REMARKS

The above amendments and these remarks are responsive to the Office action mailed on February 15, 2000. Claims 1, 3-9, 11, 12, 15-19, 21-25, 32, 36 and 37 have been amended. Claims 2, 33-35 and 38-40 have been canceled. Claims 41-47 have been added. Claims 1, 3-32, 36 and 40-47 are now pending in this application. Reconsideration on the basis of the above amendments and remarks below is kindly requested.

Application No. 09/277,918

FIG. 10

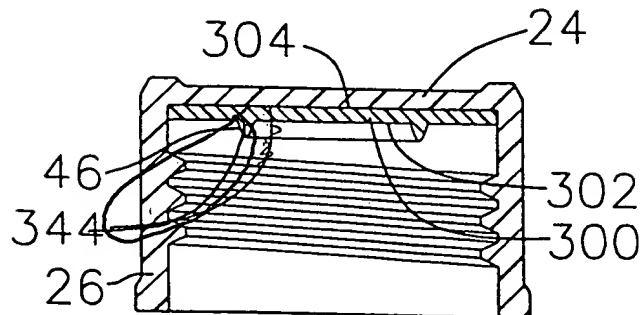
to the drawings. Specifically, FIGS. 13 and 14 have been added and FIGS. 10, 11 and 12 have been amended. FIG. 13 discloses a combination of a bottle neck, cap and disk having a circular ridge and a slot formed there across as claimed by claim 27. Claim 30 is directed to a cap, liner, disk and bottle neck combination where the disk has a circular ridge and a slot formed across the ridge. The liner has a hole through its thickness and is sandwiched between the ridge and the rim of the bottle neck. A disk having a ridge and a slot there through is disclosed in FIGS. 12 and 13. A liner having a hole through its thickness is disclosed in FIG. 7. As such, the subject matter of claim 30 is already disclosed in the drawings pending in this application. FIG. 14 discloses the combination of bottle neck, cap and disk having a plurality of grooves extending outwardly beyond the rim of the bottle neck as claimed in claim 32 as now pending in this application. FIG. 10 has been amended to correct the lead line from reference numeral 344. FIG. 11 has been amended to include a reference numeral 344 and a corresponding lead line. FIG. 12 has been amended to include reference numerals 48 and 344 and their corresponding lead lines.
